Access Compliance Report

Public Rights-of-Way

Intersection ID: 16251	Main Street: N_SHARON_AMITY_RD	Cross Street: BUENA_VISTA_AV	Location: N
ADA ID: 4231788965A8	Ramp Type: PerpDiag	Initial Pass/Fail: Fail	Overall Compliance: No
Severity Score: 13.75			
Codes/Mitigation Info/Possible Solution		Field Measurements/Component Compliance

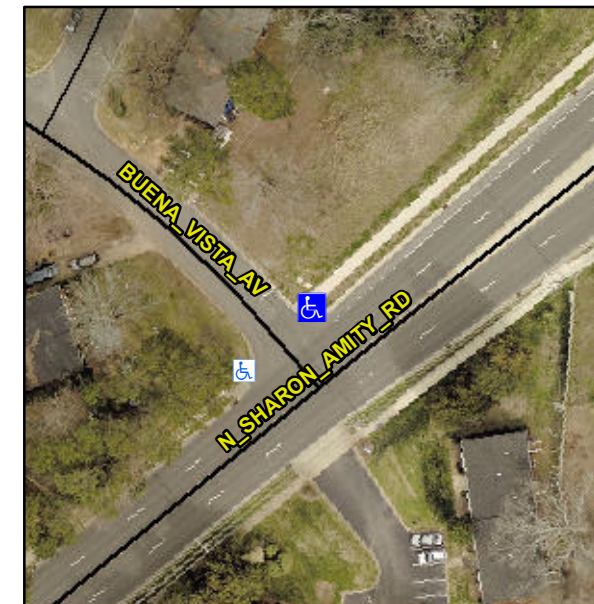
R304.2.2, R304.5.3

Compliance	Description	Data	Compliance	Description	Data
N/A	Ramp Length (in)	82.0	No	Ramp Slope (%)	8.4
Yes	Ramp Width (in)	60.0	No	Ramp XSlope (%)	3.1
N/A	Flare Type LT	N/A	N/A	Flare Type RT	N/A
N/A	Flare Slope LT (%)	N/A	N/A	Flare Slope RT (%)	N/A
N/A	Flare Traversable LT?	N/A	N/A	Flare Traversable RT?	N/A
N/A	Landing Length (in)	N/A	N/A	DWS Provided?	N/A
N/A	Landing Width (in)	N/A	N/A	DWS Contrast?	N/A
N/A	Landing Slope (%)	N/A	N/A	DWS Length (in)	N/A
N/A	Landing X Slope (%)	N/A	N/A	DWS Full Width?	N/A
N/A	Landing Curb? (Y/N)	N/A	N/A	DWS Offset (in)	N/A
N/A	Shared Landing?	N/A			
N/A	Gutter Ponding?	N/A	N/A	Gutter Slope (%)	N/A
N/A	Gutter Lip Ht (in)	N/A	N/A	Gutter X Slope (%)	N/A
N/A	Painted X Walk1?	No	N/A	Painted X Walk2?	No
	X Walk 1 Direction	To SW		X Walk 2 Direction	To SE
N/A	X Walk 1 Width (in)	N/A	N/A	X Walk 2 Width (in)	N/A
	X Walk 1 Slope (%)	4.7		X Walk 2 Slope (%)	6.3
	X Walk 1 X Slope (%)	5.3		X Walk 2 X Slope (%)	3.3

N/A	Ramp inside XWalk1?	N/A	N/A	Ramp inside XWalk2?	N/A
	Road Slope (%)	4.0	N/A	Clear Space?	N/A
	Road X Slope (%)	6.6	N/A	Clear Space to XWalk (in)	N/A
N/A	Any Obstructions?	N/A	N/A	Storm Grate/Utility Hazard?	N/A
	Obstruction Type			Storm Grate/Utility Type	
		N/A			N/A
			Yes	Surface Condition? (G/P)	Good

Remove & Replace Curb Ramp With Two New Directional Ramps or Equivalent.
